KEYSTONE XL PIPELINE PROJECT

0414-SD-P4-XXX-X-XXX.X-S

# Keystone XL Pipeline - Supplemental Information for Route Variation Report 0414

KEYSTONE XL PROJECT		
Proposed Valve Relocation 0414-01		
COUNTY:	HAAKON	DRAWN BY: PD
STATE:	SOUTH DAKOTA	CHECKED BY: JP
REV. NO.:	REVISION	DATE
0	ISSUED FOR REVIEW.	2012-07-11
PRELIMINARY		
DATE:	2012-07-11	PROJECTION: NAD83   UTM14 N

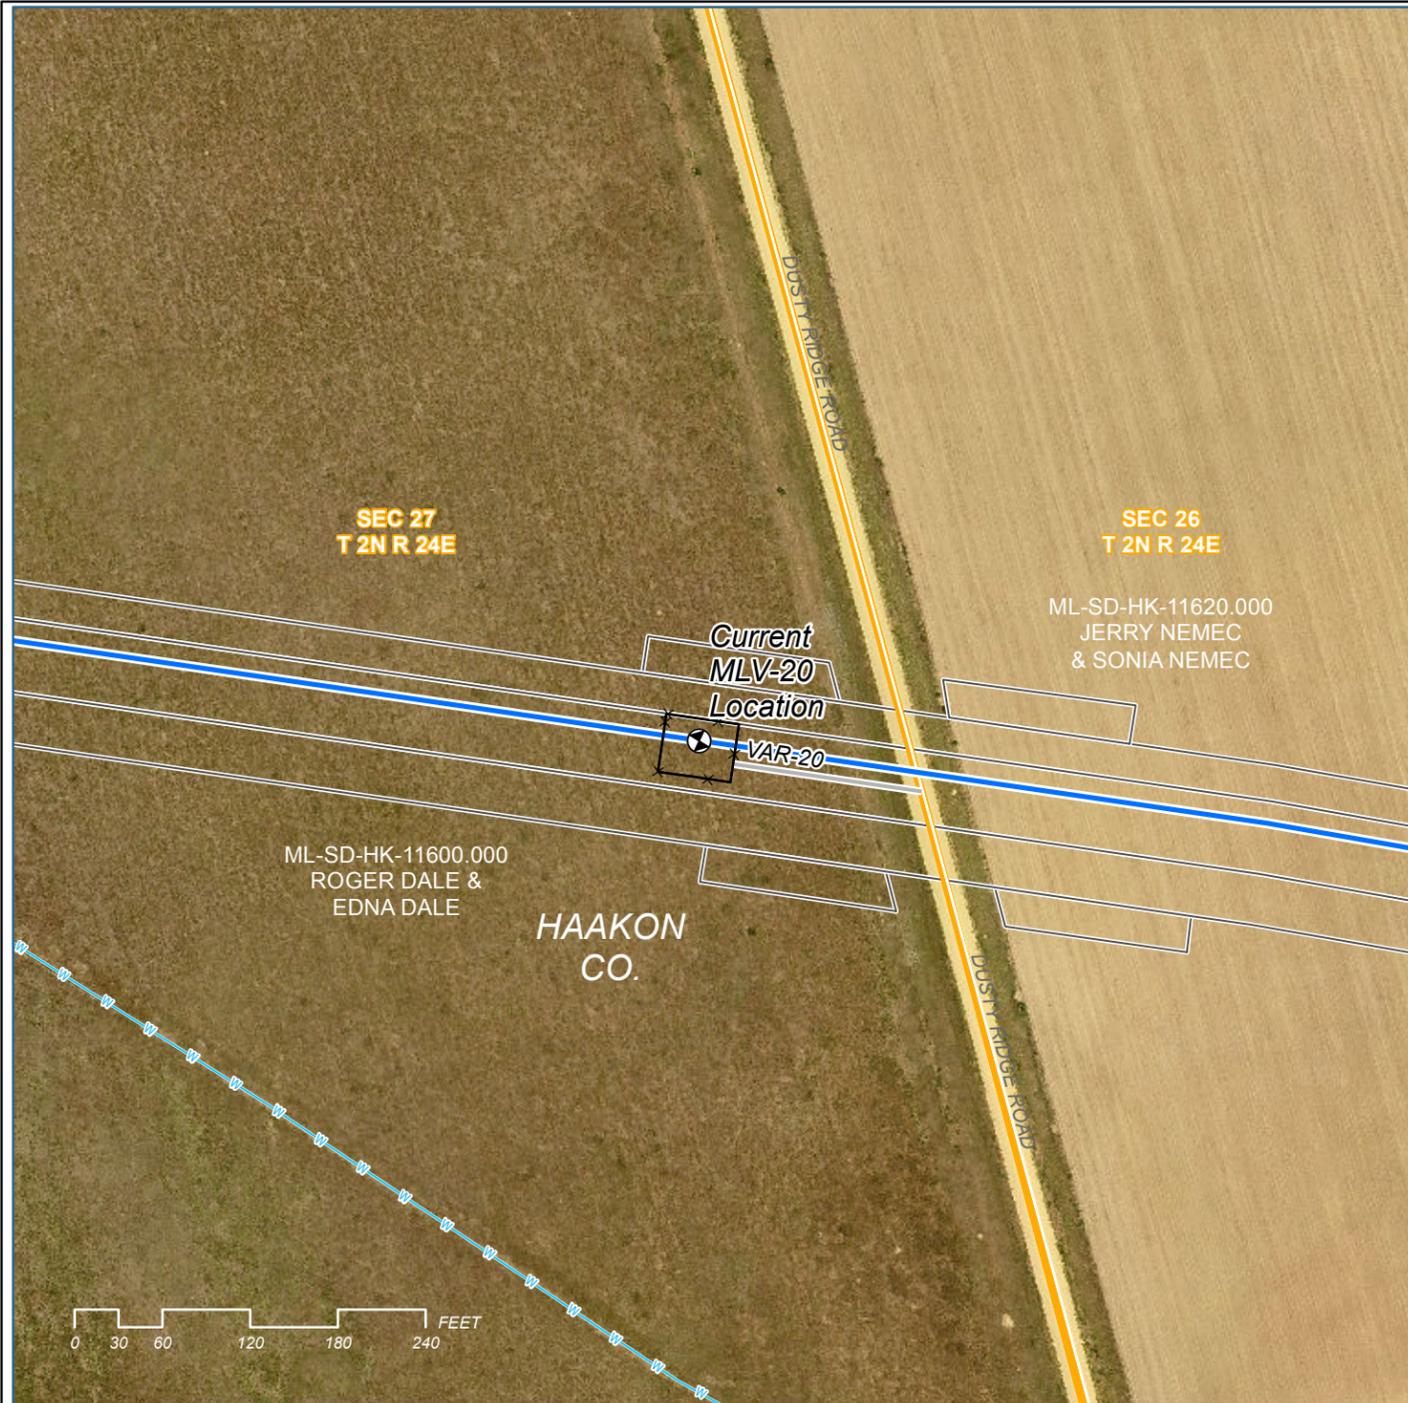
3	<b>REASON FOR ROUTE VARIATION</b> (Please include reason for route variation): <div style="border: 1px solid black; padding: 5px; min-height: 60px;">                     The primary reason for this footprint change is the relocation of MLV-20 per field reconnaissance recommendation.                 </div>		
	<b>DETAIL ROUTE VARIATION</b> (Please describe route variation in detail): <div style="border: 1px solid black; padding: 5px; min-height: 40px;">                     MLV-20: Per field reconnaissance performed of the proposed site on 6/19/2012. Proposed location upstream of CAR-161 is good location. Slightly higher ground with mild slope and all crop. Power is available downstream of road and access road is good and reported by Land to be county maintained. Recommendation to place valve on Coming inside of road due to dual power lines located south of field road.                 </div>

<b>ADDITIONAL IMPACTS</b> (Please include any additional impacts which may affect cost; crossings, induction bends, etc.): <div style="border: 1px solid black; padding: 5px; min-height: 80px;">                     1 Tract impacted:                      HK-11620 (Jerry Nemeec &amp; Sonia Nemeec) - Proposed MLV-20 new location.                      HK-11600 (Roger and Edna Dale) - Current MLV-20 location                 </div>		
	Is there an increase/decrease in the number of crossings? Yes <input type="text"/> No <input checked="" type="checkbox"/>		
	If yes, please list: <input type="text"/>		
	<b>COST ANALYSIS</b> (costs incurred or saved from the route variation)		
	Additional length of route realignment:	<input type="text" value="0"/> ft.	\$ - \$ 360/ft
	Additional length of side-hill construction:	<input type="text"/> ft.	\$ - \$ 19/ft
	Additional length of wetland construction:	<input type="text"/> ft.	\$ - \$ 195/ft
